ADDENDUM

AM 04

PROJECT : Forestside
PROJECT # : 1331.15
DATE : August 24, 2020

Title: Updated drawings

CONDITIONS FOR ELECTRONIC INFORMATION TRANSFER:

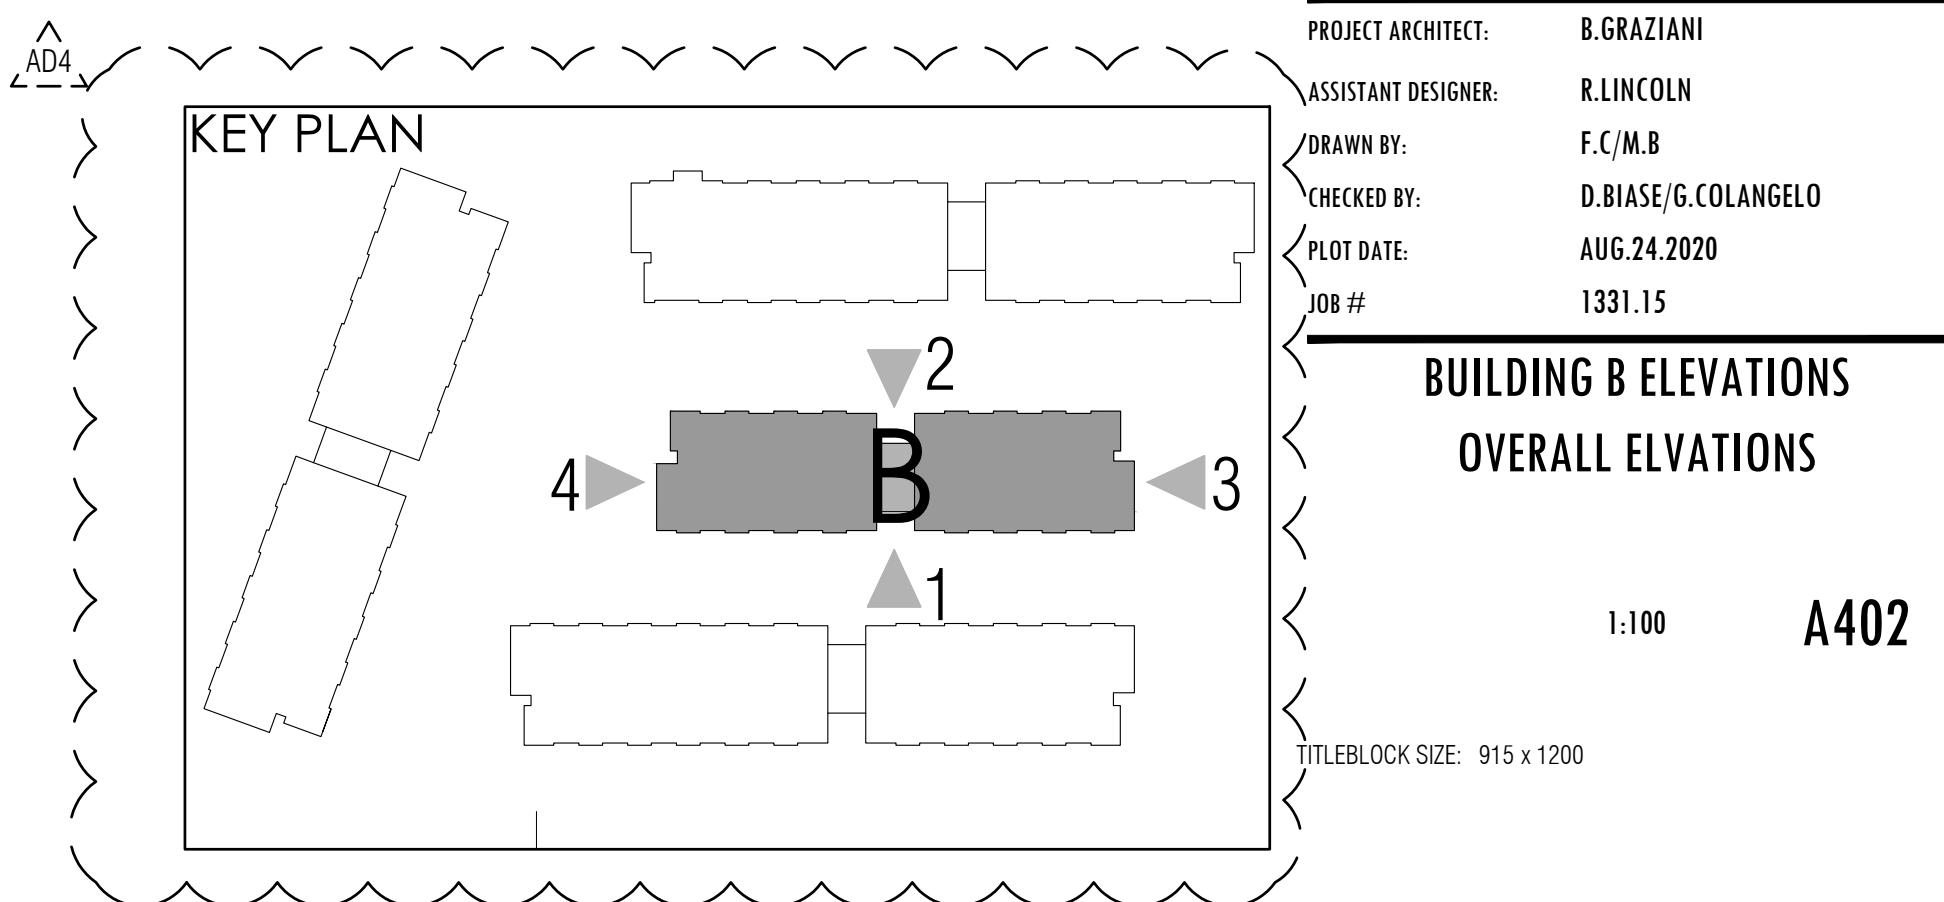
Reference:		Changes:
A-102	Wall Schedule	Revised Insulation and Sheathing on Exterior Brick, Stone, Concrete and Concrete Block walls to Spray Foam Insulation and Securock (CGC) Sheathing.
A-401 A-402 A-403 A-404	Building A Elevations Building B Elevations Building C Elevations Building D Elevations	Revised Key Plan Legend to match block elevation designation.
A-500	Building Sections	Revised all sections elevations to match updated exterior wall changes above.
A-600	Wall Sections	- Revised all wall sections to match updated exterior wall changes above. - Revised shelf angle location to be between suites on 3rd and 4th floor where it is one suite to act as Firestop and Added Firestop to floors in between suites at lower levels that do not require shelf angle.
A-900	Section Details	Revised all wall sections to match updated exterior wall changes above.
